SUBJECT: COMANCHE PEAK NUCLEAR POWER PLANT, UNITS 1 AND 2 – FLOOD
HAZARD MITIGATION STRATEGIES ASSESSMENT (CAC NOS. MF7913 AND
MF7914)

STAFF ASSESSMENT BY THE OFFICE OF NUCLEAR REACTOR REGULATION
RELATED TO MITIGATION STRATEGIES FOR COMANCHE PEAK NUCLEAR POWER
PLANT, UNITS 1 AND 2, AS A RESULT OF THE REEVALUATED FLOODING HAZARD
NEAR-TERM TASK FORCE RECOMMENDATION 2.1
CAC NOS. MF7913 AND MF7914

Figure 3.2-1 Comanche Peak Site Layout Adapted from Flood Hazard Reevaluation Report

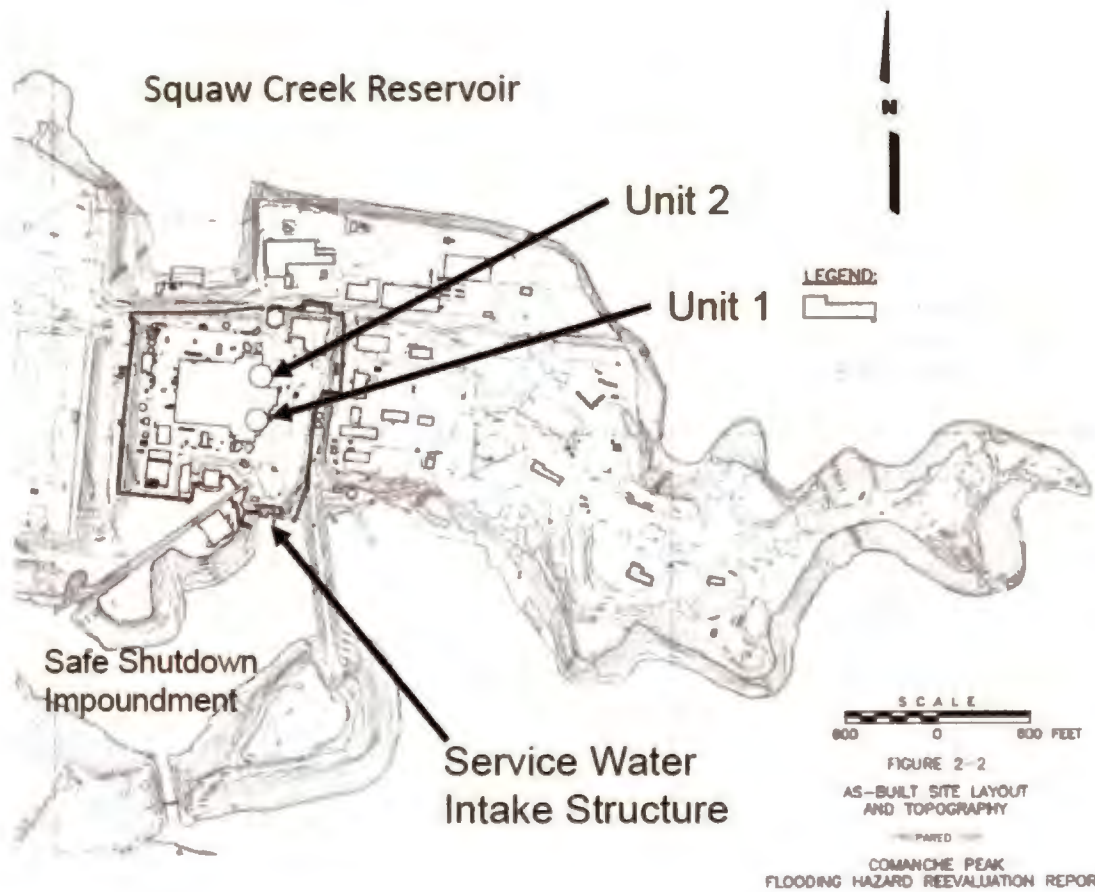
Figure 3.2-1, which is adapted from the licensee's supplement to the flood hazard reevaluation report (FHRR) dated August 14, 2014 (ADAMS Accession No. ML14245A136), provides a site layout for the plant. Section 3.3 and 3.4 of this report provides the staff's assessment of the AE parameters and FED parameters, respectively, provided by the licensee in its MSA. The AE and FED parameters were found to be acceptable by the staff and are considered in the staff's assessment of the current FLEX strategies against the reevaluated hazard LIP and streams and rivers PMF that is provided below.
